# UNITED STATES PATENT AND TRADEMARK OFFICE

10/529,046

<b>Office Action Summary</b>	<b>Application No.</b> 10/529,046	<b>Applicant(s)</b> KORDON ET AL.	
	<b>Examiner</b> JOSEPH CORRIGAN	<b>Art Unit</b> 3744

## **DETAILED ACTION**

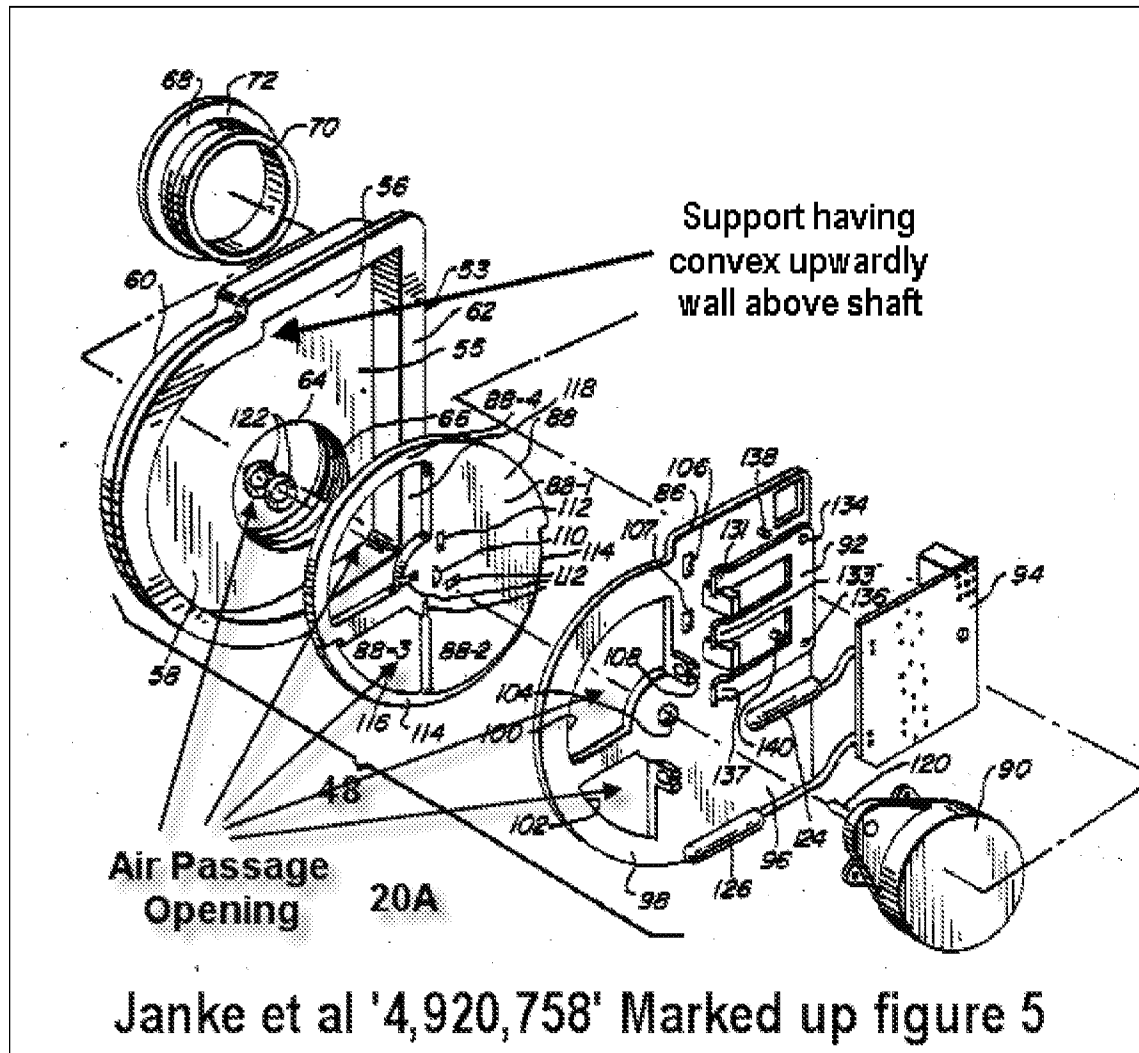
In re claim 15, Janke et al '758 discloses a storage chamber (22, figure 1); an evaporation chamber (20, figure 1); an air passageway (47, figure 4) having a plane and enabling air exchange between said storage chamber (22, figure 1) and said evaporation chamber (20, figure 1); said air passageway (47) having an air passage opening (47) having a cross-section; a control body (88, figure 5) arranged on said air passage opening (47); said control body (88, figure 5) shiftable between positions (column 6, lines 46-50) in which said control body (88, figure 5) variously covers said cross-section of said air passage opening (47); and said control body (88, figure 5)

rotatable about an axis (see marked up figure 5, ghost line traveling through center of motor shaft) substantially perpendicular to said air passageway (47) plane. Please note that the freezer compartment is being identified as evaporation chamber since air sent through evaporator passes through fan aperture (28) and is stored in this compartment.

In re claim 21, Janke et al '758 discloses invention above and further discloses a support (53, figure 5) formed on said air passage opening (47, figure 4), said support having convex upwardly walls (see marked up figure 5 above) above said shaft (120). Please note that inside wall of insert threaded sleeve is considered "convex upwardly walls" as required in claim limitation. (See column 4, lines 65-68 through column 5, lines 1-3)
